Video Products Technical Bulletin 30-2012-054

DATE: **May 21, 2012**SUBJECT: **TALLY CANNOT BE TURNED OFF**MODEL: **BVM-E170
BVM-F170****DESCRIPTION**

Figure 1

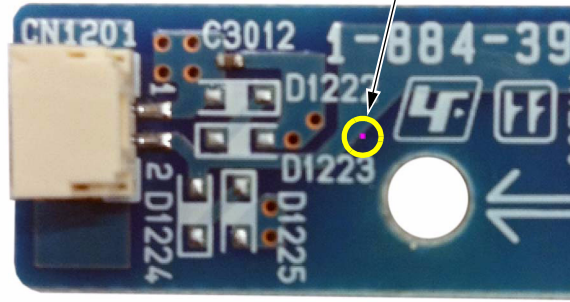
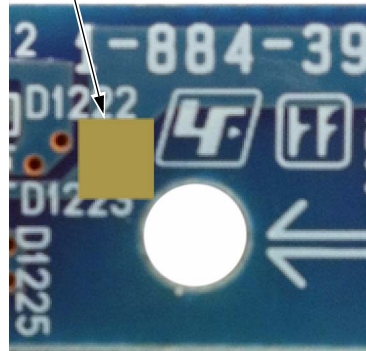
The tally keeps lighting when power is turned ON, and the tally cannot be turned OFF, even if the tally is set to OFF with the parallel remote.

BOSS TOUCHES TRACE HERE

ADD INSULATION TAPE

1. Remove the BZL frame and OLED module.
2. Remove the YA board from the BZL frame, and remove the harness from the YA board.
3. Affix a 5 mm × 5 mm piece of insulation tape to the area shown in Figure 1.
NOTE: The tape prevents the boss on the top plate from touching the trace.
4. Reinstall the harness to the YA board, and reinstall the YA board to the BZL frame.
5. Reassemble the unit.
